UNITED STATES PATENT AND TRADEMARK OFFICE

Office Action Summary

10/072,990

The following title is suggested: --A Gas Turbine Engine Exhaust Nozzle Having A Noise Attenuation Device Driven By Shape Memory Material Actuators--.

FIG. 1

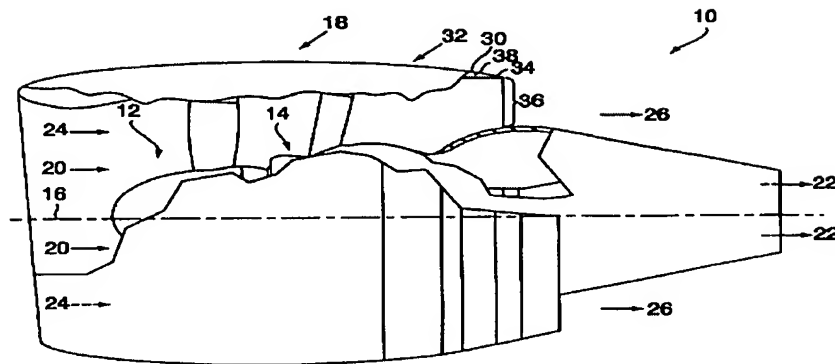
- 18. With respect to claim 1, **Rey et al.** teach a gas turbine engine exhaust nozzle arrangement for the flow of exhaust gases therethrough between an upstream end and a downstream end thereof comprising a nozzle, a downstream portion and a plurality of tabs 38, each tab 38 extends in a generally axial direction from the downstream portion of the nozzle wherein the nozzle further comprises an actuation mechanism capable of moving the tabs between a first deployed position, in the first position the tabs interact with a gas stream to reduce exhaust noise thereof, and a second non-deployed position, in the second position the tabs are substantially aerodynamically unobtrusive. See particularly **Figures 1 and 2 of Rey et al.**

- ✓ 19. With respect to claim 2, **Rey et al.** teach that the plurality of tabs 38 are circumferentially disposed about the nozzle. See particularly **Figures 1 and 2 of Rey et al.**

- ✓ 30. With respect to claims 48-50, **Rey et al.** teach that exhaust nozzle arrangement comprises a core exhaust nozzle and a bypass exhaust nozzle. See particularly **Figure 1** of **Rey et al.**
- ✓ 31. With respect to claim 53, **Rey et al.** teach that the downstream end of the bypass nozzle is upstream of the downstream periphery of the core exhaust nozzle. See particularly **Figure 1** of **Rey et al.**
- ✓ 32. With respect to claim 55, **Rey et al.** teach that the tabs extend generally in a downstream direction. See particularly **Figure 2** of **Rey et al.**
- 33. With respect to claim 57, the operation of the prior art apparatus of **Rey et al.** will inherently perform the claimed method.

FIG. 2

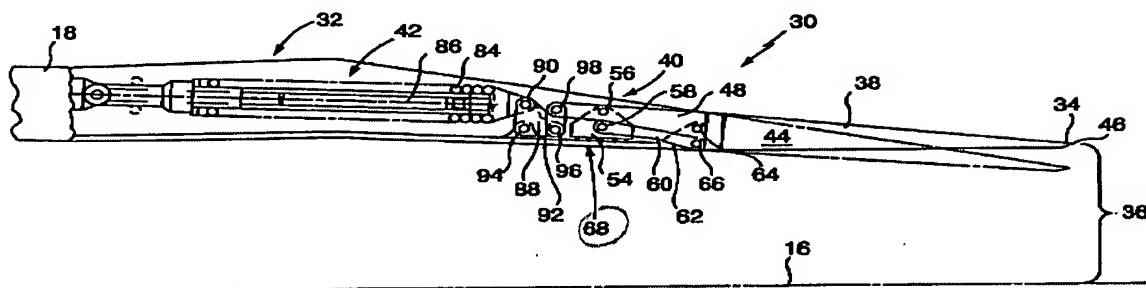
20. With respect to claim 3, **Rey et al.** teach that the actuation mechanism comprises a shape memory material element 68. See particularly **Figure 2 of Rey et al.**

21. With respect to claim 5, **Rey et al.** teach that the periphery of the nozzle defines a pocket therein and at least a part of the element 68 is generally disposed within the pocket. See particularly **Figure 2 of Rey et al.**

- ✓ 27. With respect to claim 25, **Rey et al.** teach that the downstream portion of the nozzle comprises a downstream periphery, the plurality of circumferentially disposed tabs 38 extend in a generally downstream direction from the downstream periphery. See particularly **Figure 2** of **Rey et al.**
- ✓ 28. With respect to claim 30, **Rey et al.** teach that the tabs circumferentially taper in the downstream direction. See particularly **Figure 2** of **Rey et al.**
- ✓ 29. With respect to claims 41 and 43, **Rey et al.** teach that the taps 38 have a first shape in the deployed position and a second shape in the non-deployed position. In the deployed position, the first shape has a first length which is longer than a second length (when the tap is in the non-deployed position, second shape). See particularly **Figures 2, 3, 9 and 10** of **Rey et al.**

FIG. 6

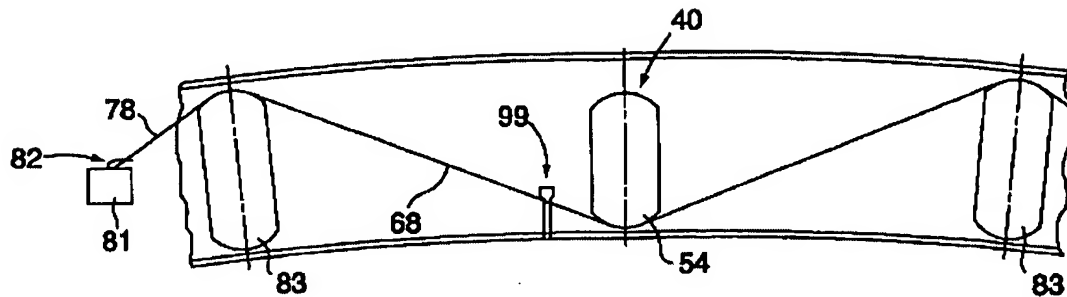
26. With respect to claims 19-21, **Rey et al.** teach that to actuate the taps 38, the control system 81 applies heat or voltage across the SMA material to heat the SMA actuator. See particularly **Figure 6 of Rey et al.**
